STRAND RANCH INTEGRATED BANKING PROJECT

Final Environmental Impact Report

Prepared for:
Rosedale-Rio Bravo Water Storage District

May 2008

Figure 2-3
Strand Ranch Recovery Facilities

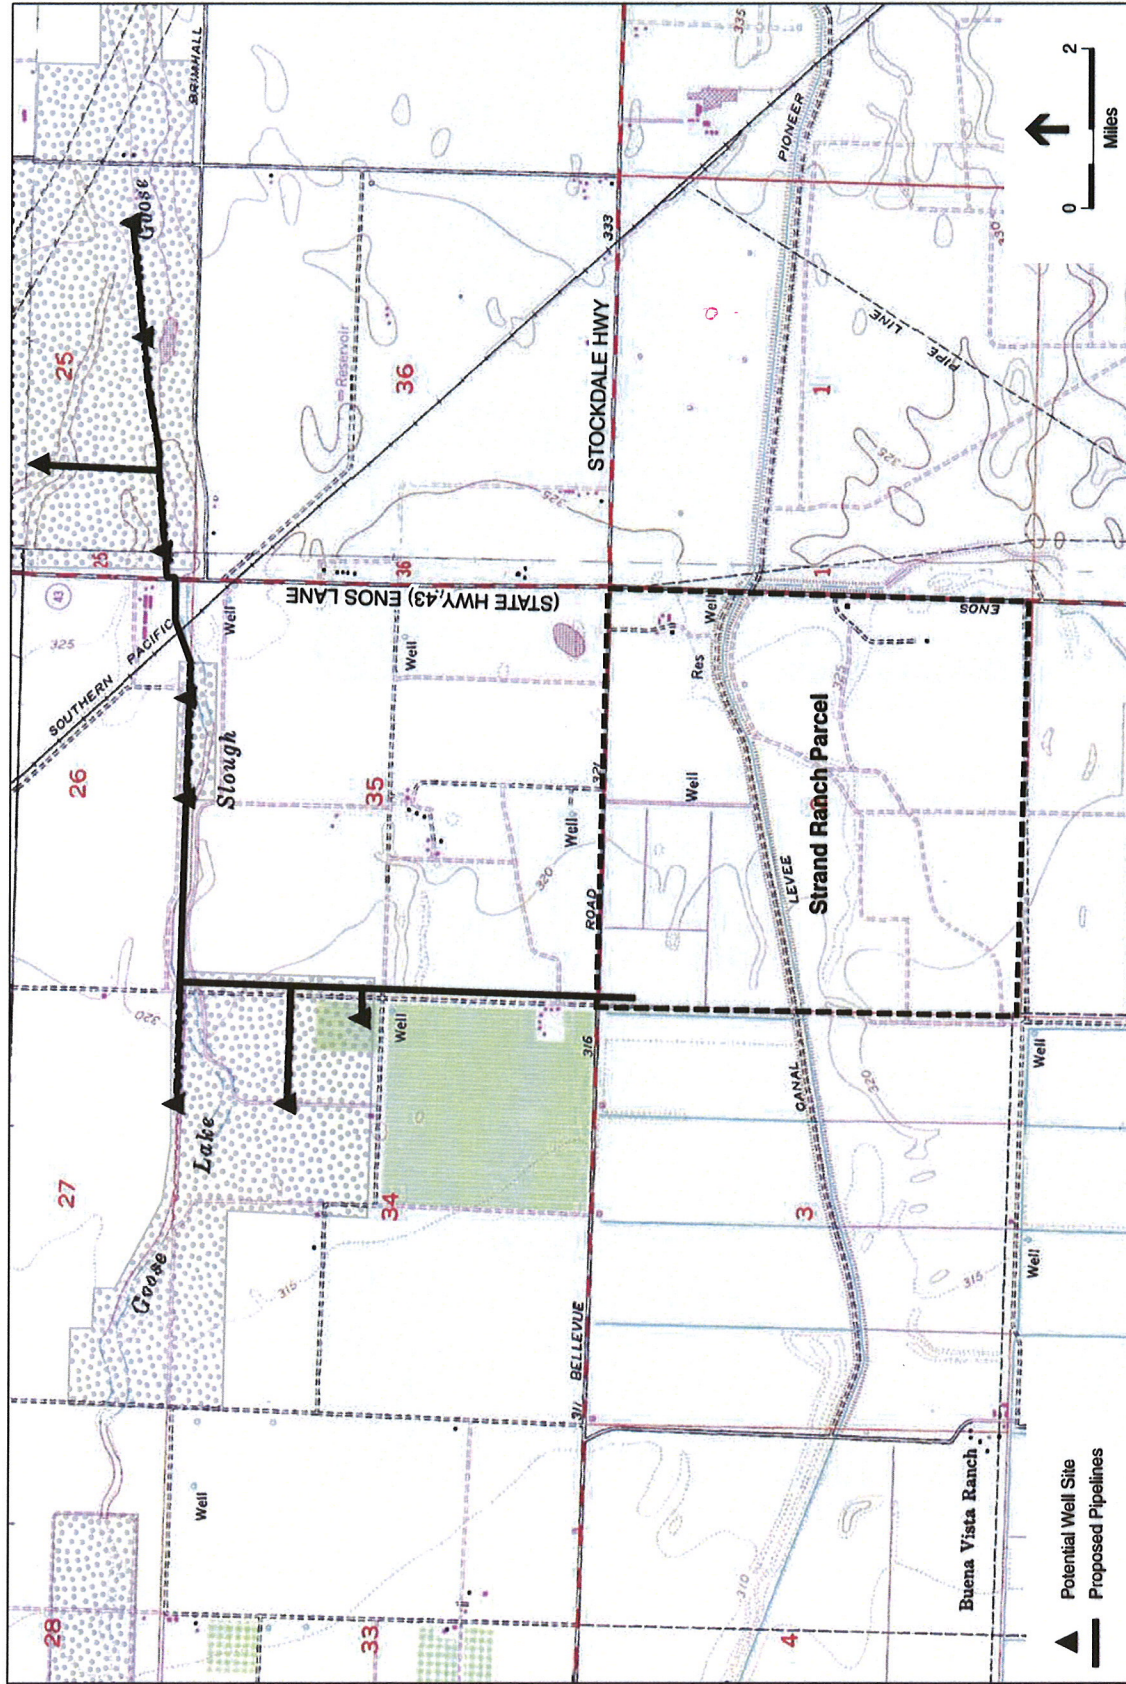
Figure 2-3 shows wells on the Strand Ranch at 1/3-mile spacing. This spacing places the southwestern well less than 1/4 mile away from an existing KWB well (30S/25E-3R). This proposed location will minimize impacts between Strand Ranch wells at the expense of creating significant impacts to this offsite well on the Kern Water Bank. The southwestern well location should be at least 1/3-mile from well 30S/25E-3R, as mitigation.¹¹

As a practical matter, the EIR points out that the well field is proposed to be laid out within the available area defined by the setback distances and with spacings and orientations in such a way to meet project objectives and to minimize the drawdown impacts on adjacent wells. The proposed project anticipates from 5 to 8 wells on the Strand Ranch. For well-field scenarios containing less than nine wells, the likely well placements would be such that one or more of the proposed locations (shown in Figure 2-3) which would not be used are those closest to the southern project boundary separating the Strand Ranch property and the KWB property, all else being equal.

Figure 2-3 has been modified to say "Potential ~~Proposed~~ Well Locations"
